MIL-C-85003B(AS)
AMENDMENT 1
21 OCTOBER 1986

MILITARY SPECIFICATION

CHAFF CARTRIDGE (TYPE RR-()/AL), GENERAL SPECIFICATION for

Figure 2. Chaff Cartridge Critical Design Vibration, Takeoff Portion (2 minutes)

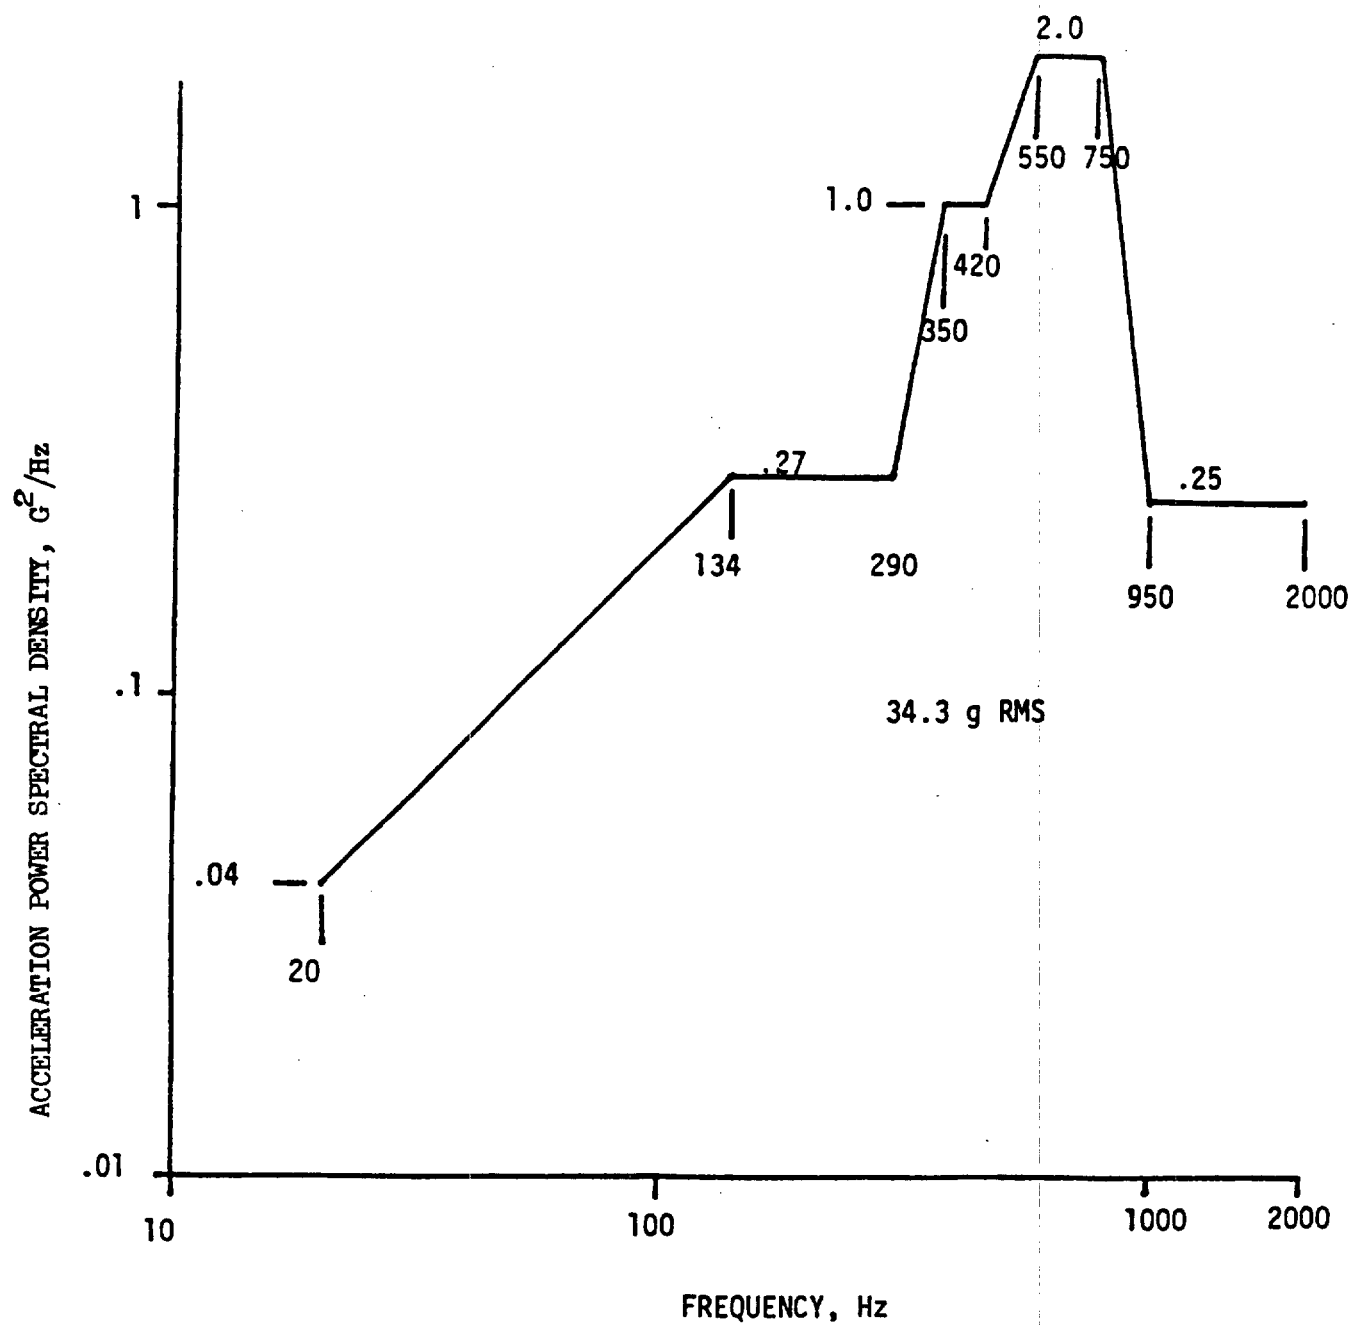
"4.10.6.1b Critical Design Vibration in accordance with Figure 2, for two minutes in each axis. Followed by Critical Design Vibration in accordance with Figure 3, for eight minutes in each axis."

FIGURE 2: Delete in its entirety and substitute new FIGURE 2, as PAGE 16a.

Figure 3. Chaff Cartridge Critical Design Vibration,
Level Flight Portion (8 minutes).

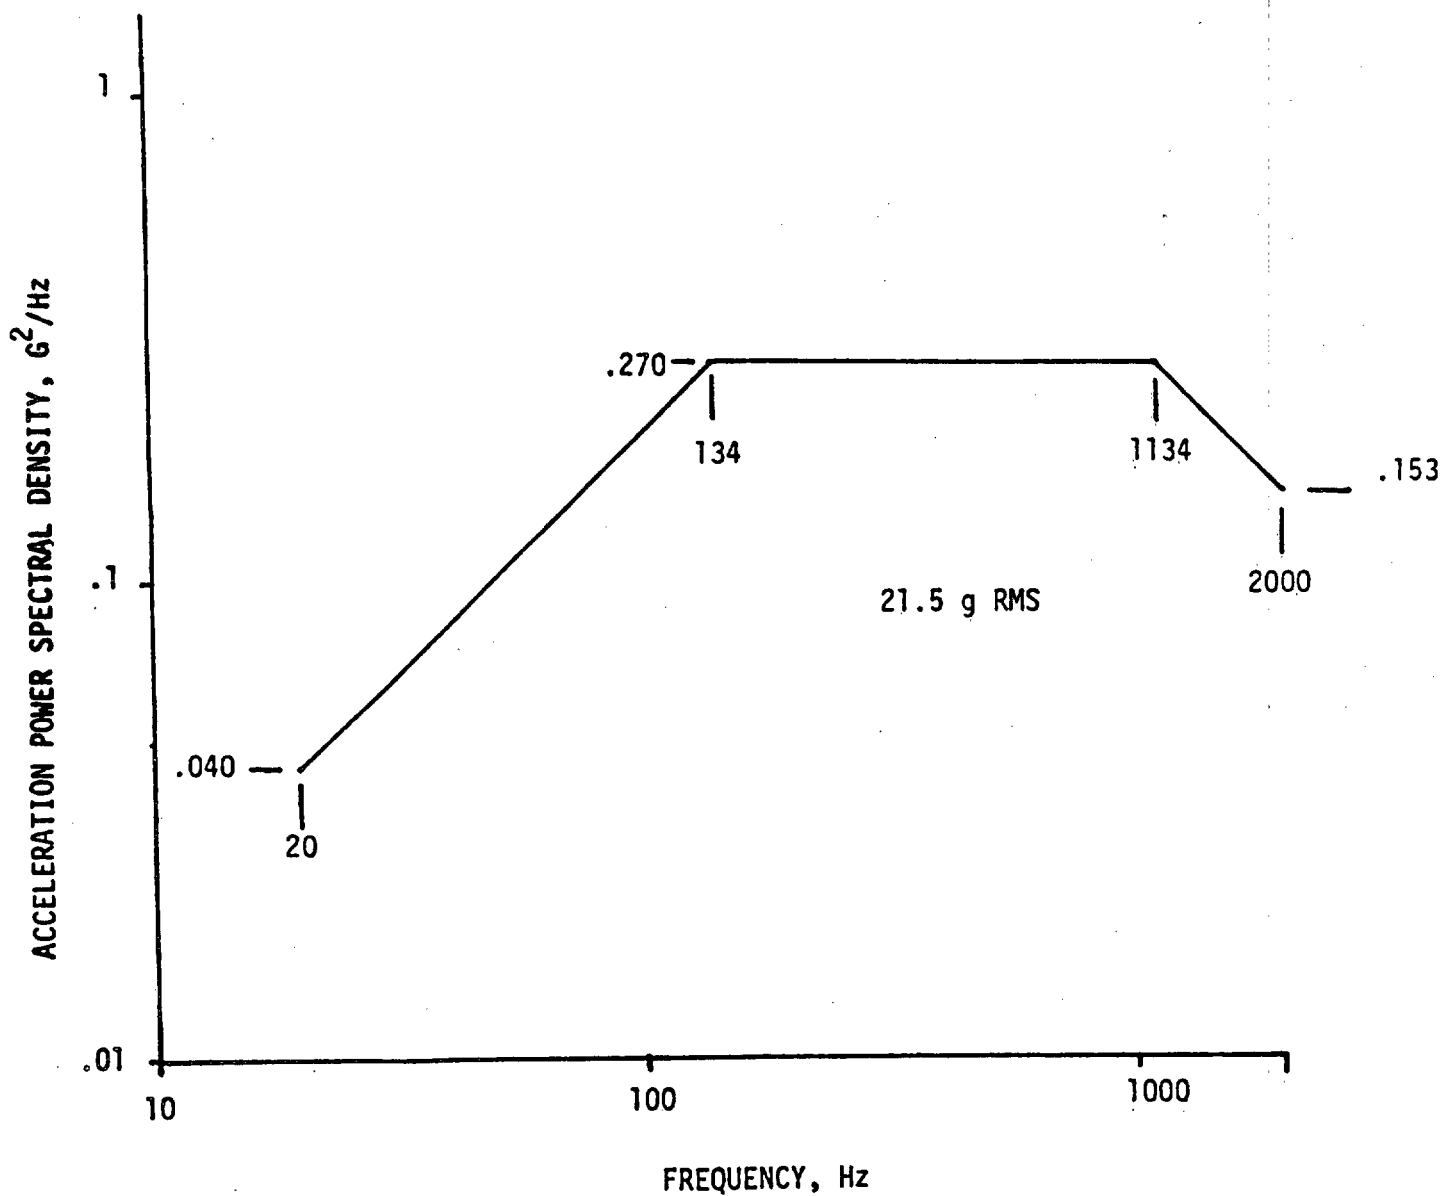
Following PAGE 16a insert new FIGURE 3, as PAGE 16b.
